GOVERNMENT HILL COMMUNITY COUNCIL

February 19, 2008

Subject: Please do not sign the Memorandum of Agreement for Section 106 negotiations under 36 CFR 800.6(c) Regarding the Knik Arm Crossing Project HDP-CA-0001(277)/56047

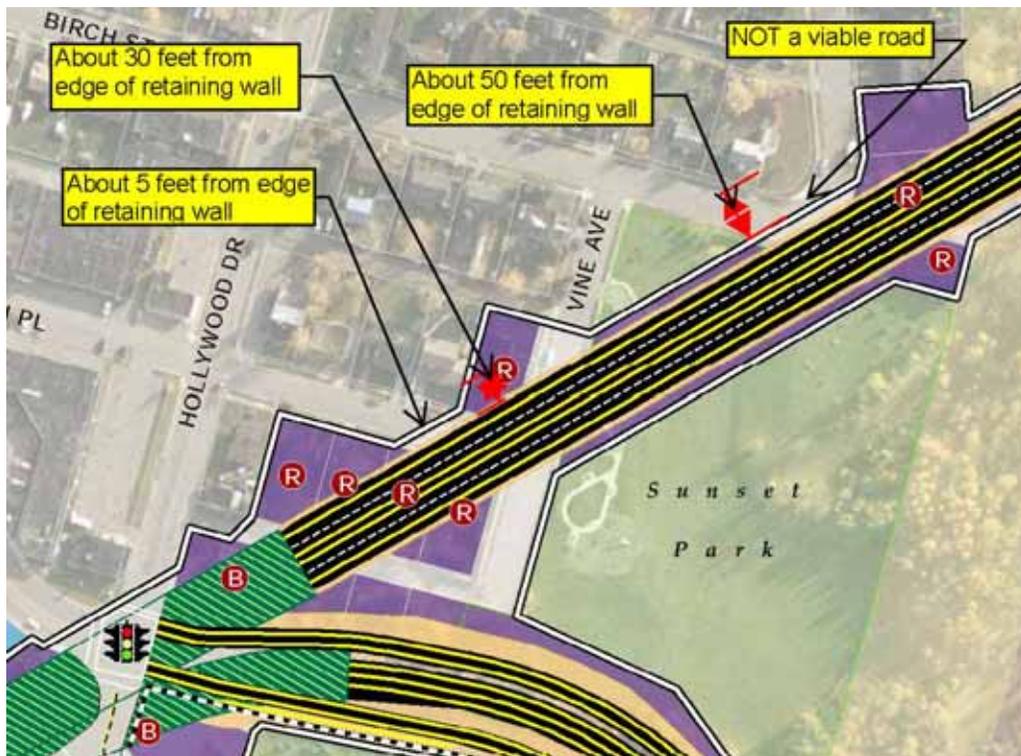
The FEIS in Map 8-P2 on page S-31 shows the preliminary design as the approach road comes out of the Phase 2 Erickson Tunnel and raises up to cross Sunset Park. The following is an enlargement.

The tunnel under Government Hill is estimated to be at least 25 feet and possibly 30 feet below grade, due to the necessity of maintaining utilities from the east side to the west side of Government Hill, and still having adequate clearance. Figure 2.36 indicates a 10 foot setback from the edge of the concrete walls of the tunnel to the edge a sheet pile wall, and another 10 feet to the edge of the right of way. Working within driven sheet pile walls only 10 feet from the right of way will cause much higher (from 1.5 to 2 times as high) costs than conventional construction without sheet piles. The number and type of utilities that cross through the area of the Erickson Tunnel including a 24” reinforced concrete sewer main, multiple water lines, natural gas lines, overhead power lines, abandoned utilities (this is Anchorage’s first neighborhood) and fiberoptic cables that enable phone and internet connections for about half of Alaska, the concept of working inside sheet pile walls quickly becomes cost prohibitive. Those costs are driven higher because of the contaminated soils due to leaks from the former Defense Fuels site, leaks from the Defense Fuels pipeline, and asbestos, lead paint and fuel oil contamination at Sunset Park, at the former location of the Government Hill Elementary School that was destroyed by the 1964 earthquake. Some of those haz-mat costs were not identified in the FEIS.

Due to KABATA’s self-imposed requirement to keep the costs under \$600 million for Phase 1, we believe that KABATA will be forced to cut costs wherever they can, and that will cause them to use conventional excavation for this tunnel. Utilizing conventional construction, the set-backs for a 30 foot deep tunnel in unconsolidated sand and gravel would be about 60 feet from the bottom toe of the slope. This is why the Set-backs for the Right of Way, and of the project footprint were shown as being larger for the Degan Variant than the Erickson Variant. It is one way how KABATA had their thumb on the scale when measuring the differences between their two, nearly identical, variants.

It is our estimate that this will cause the demolition or right-of-way acquisition during Phase 1 of the properties at 820 E. Loop, 432 Manor, and 433 E Harvard. We believe that the Quonset Hut at 820 E. Loop road, should have also been considered as a contributing historic element.

For Phase 2, we estimate that the properties at 742 Ash St., 621 Vine St. and 675 Birch St which are contributing elements to the Government Hill Urban Renewal Historic District, as well as 711 Ash St., which was not recognized as a contributing element, will be demolished or acquired for right of way.
